From: Laura Gibbons
Sent: 25 April 2019 16:46
To: 'Adam Shephard'
Cc: Christian O'Brien; Rob Wilson; James Bragg; David Innes; Andrew Wood; Chris Harrison
Subject: RE: Windroos, Littlehampton

There are still some issues with the details:

Title		Concrete Ring Soakaway		
Scale	1:20	At original	A4	© Robert Clark Associates Ltd
Drawing Number	1767/D5.2			Revision
				-

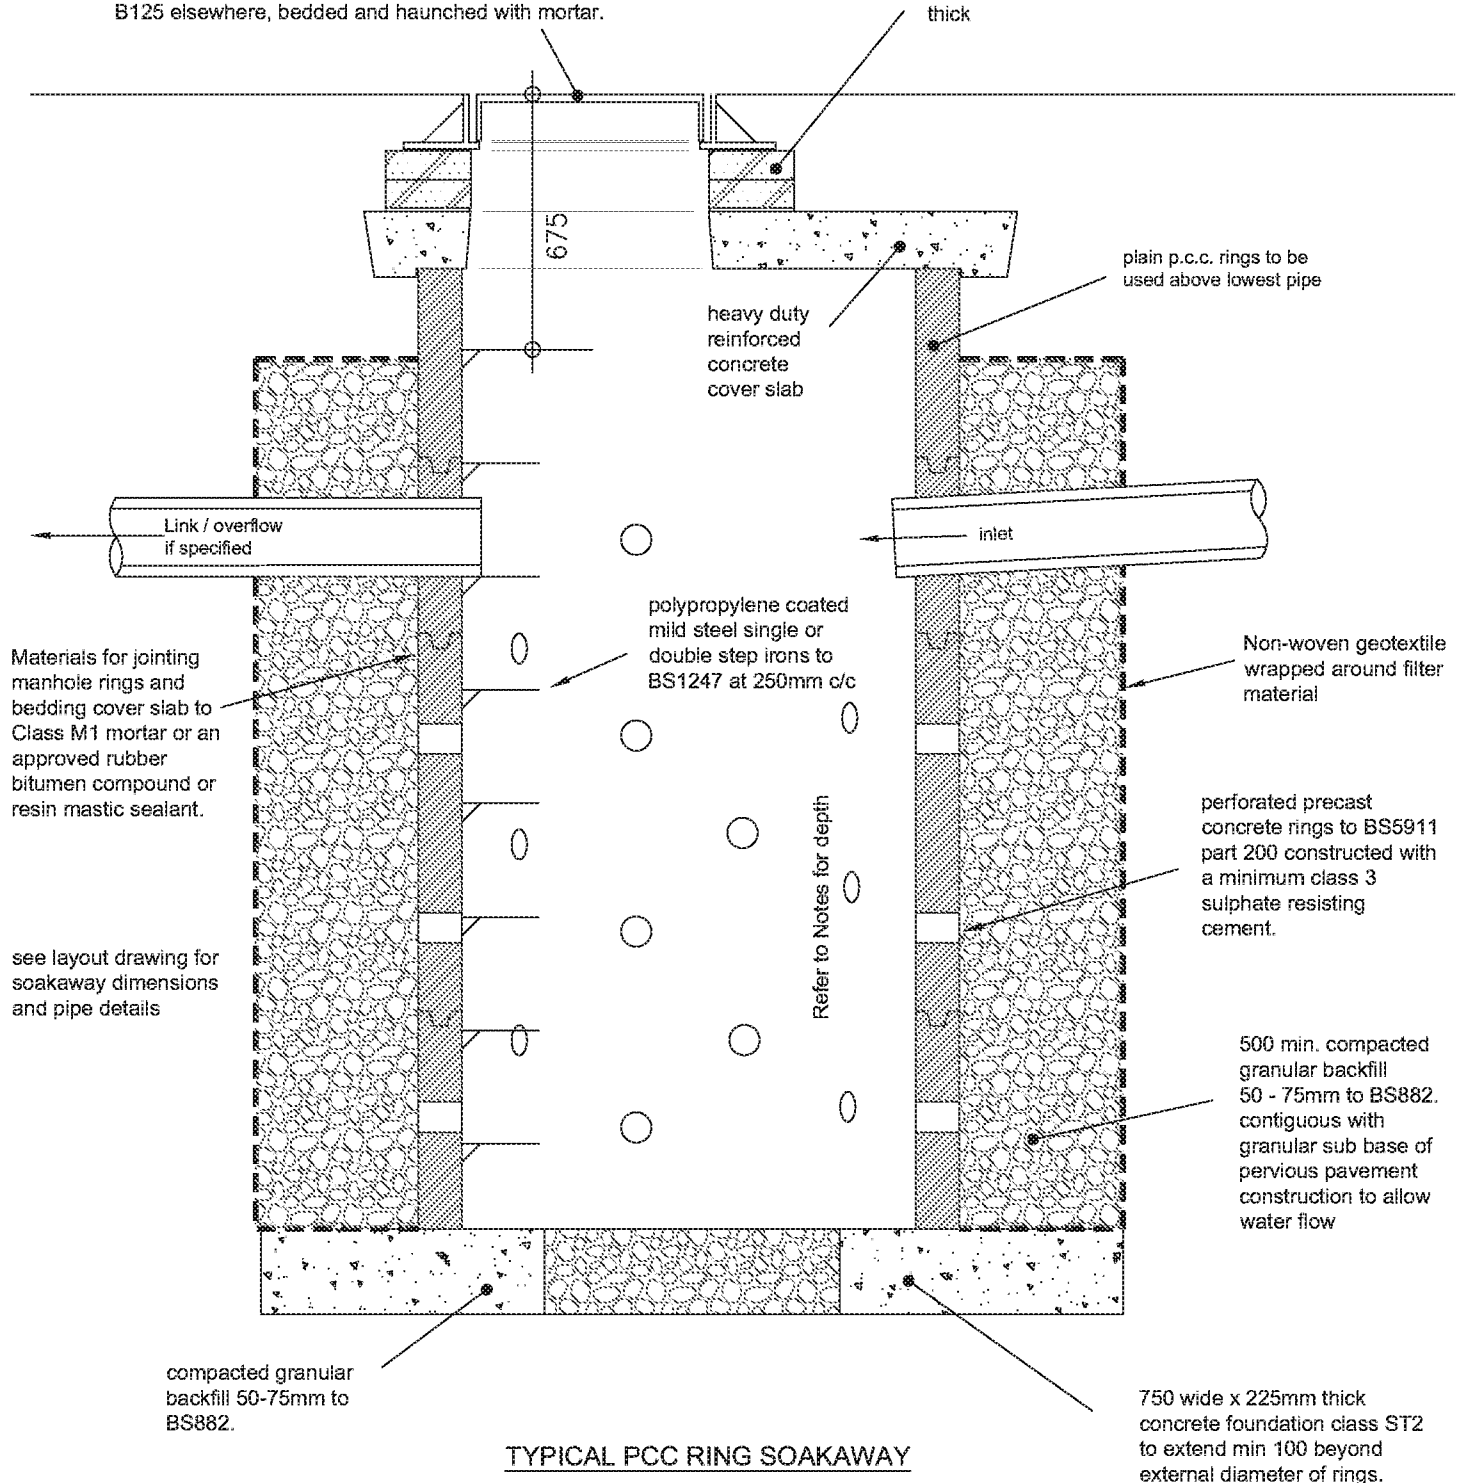
6. Cover levels at soakaways are not provided. These must be detailed.
7. Catchpits need to be labelled with sump depths.
8. Ring soakaway drawings need updating to show step irons, clean granular surround, geotextile, hole in base, etc. Please see attached document for an example.
